10-28 Biloela Street Villawood NSW 2163

Use of the existing unit as a food and drink premise and retrospective approval for the use of the unauthorised alteration and addition at the premise.

ISSUE	REVISION	DATE	PROJECT:
A	INITIAL SUBMISSION	07/10/2022	10-28 Biloela Street Villawood NSW 2163

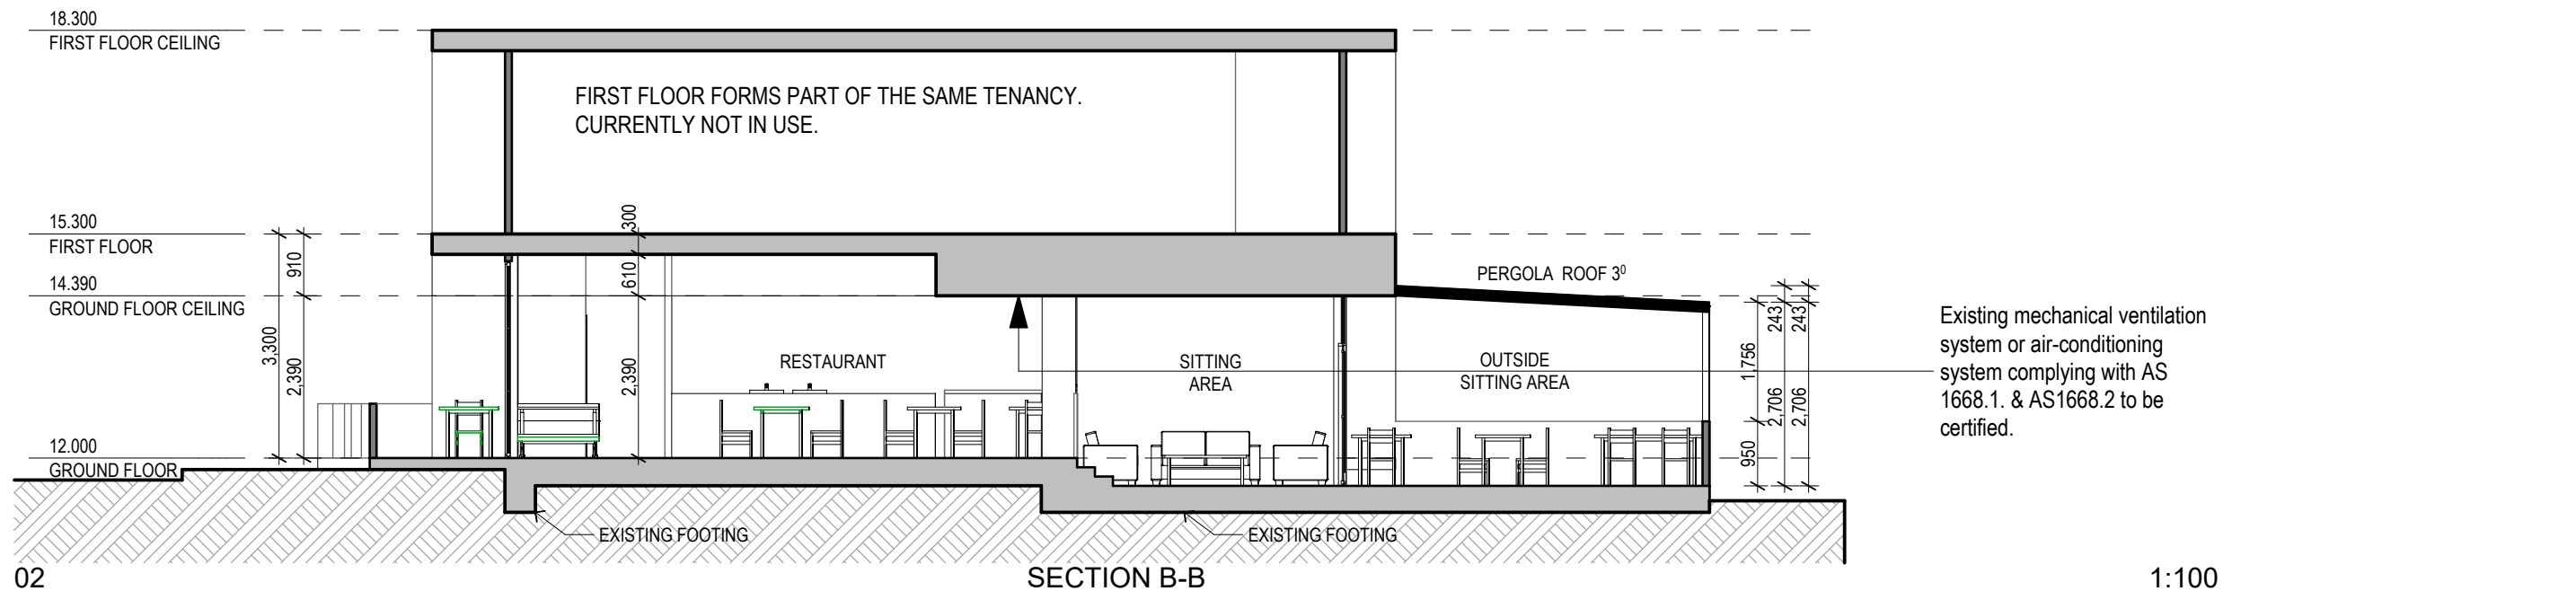
Recommended Works

- 1. Proposed separation of restaurant (Class 6) from adjoining College/ Gym tenancy (Class 9b) to comply with requirements of clause C2.7 of the BCA.
- 2. Fire wall with an FRL of 90/90/90 is required for both classes of buildings (Class 6 & Class 9) To comply with Spec. C1.1.

- 3. Required inter-tenancy fire wall to comply with Table 5 for Type C Construction of Spec. C1.1. Details to be shown on plans.
- 4. Where lightweight construction wall system is used it must comply with the requirements of this clause. To be detailed on plans.

- 5. Any penetrations in the inter-tenancy fire wall to comply with the requirements of specification C3.15.
- 6. Main front entry door opposite to non-fire isolated stairs leading to upper Mezzanine floor, is to swing out in the direction of egress or to be fitted with hold open device.

- 7. All doorways including fire door in kitchen must be provided with latches compliant with the requirements of this clause.
- 8. One space for every 100 carparking space or part thereof to be shown on plans and identified with signage.

- 9. Tactile ground surface indicators (TGSi) must be provided to warn people who are blind or have a vision impairment that they are approaching stairway, in accordance with the requirements of this clause and AS 1428.4.1-2009.

- 10. Braille and tactile signage must be provided in accordance with this clause and AS/NZS 1428.4.1-2009.To be confirmed at CC Stage.
- 11. Where an exit is not readily apparent to persons occupying or visiting the building, then exit signs must be installed in appropriate positions in corridors, hallways, lobbies, foyers, indicating the direction to a required exit.

- 12. All Illuminated exit signs must comply with AS 2293.1-2005.
- 13. Existing commercial kitchen exhaust system to be certified by a qualified person.

The works noted in the body of the report shall be implemented and details must be provided to the Council prior to the issue of the Construction Certificate. Additional mark ups below provided for extra clarity.
